# Economic and Social Council

**Regulation No. 87 (Daytime running lamps)**

### **Proposal for Supplement 17 to Regulation No. 87 (Daytime running lamps)**

**Submitted by the expert from the Working Party "Brussels 1952"\***

**Figure 1a**

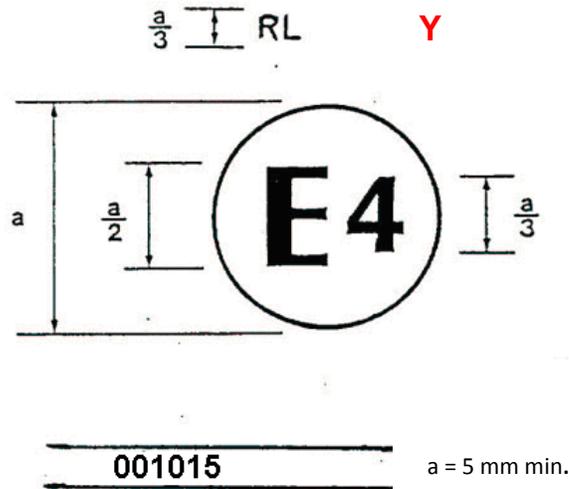
Annex 2, Insert new example of the approval mark, to read (the amendment is marked in RED):

The lamp bearing the approval mark shown above has been approved in the Netherlands (E4) under number 001015 as a part of an interdependent lamp system composing a daytime running lamp. The approval number indicates that the approval was granted according to the requirements of this Regulation in its original (un-amended) form. "
